ALERT SERVICE BULLETIN

NO. 222-99-85
DATE 12/16/99
PAGE 1 of 4

MODEL AFFECTED: 222 and 222B

SUBJECT: TAIL ROTOR PITCH CHANGE BEARINGS P/N 222-312-753-103, INSPECTION OF; AND TAIL ROTOR BLADE ATTACHING HARDWARE, REPLACEMENT OF

FIGURE 1

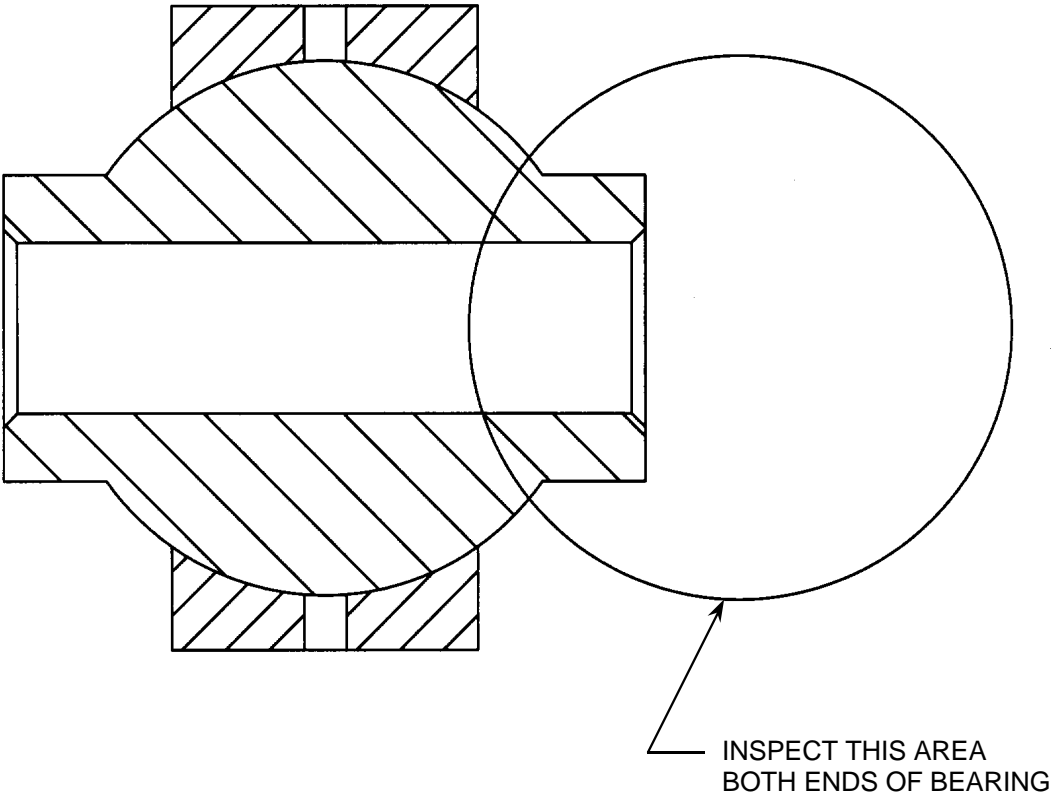
3. Visually inspect each bearing inner member neck area (full 360 degrees) for cracks. Refer to figure 1. If crack(s) are found in a bearing, the replacement of both bearings in that blade are required. Refer to BHT-222-CR&O-3.
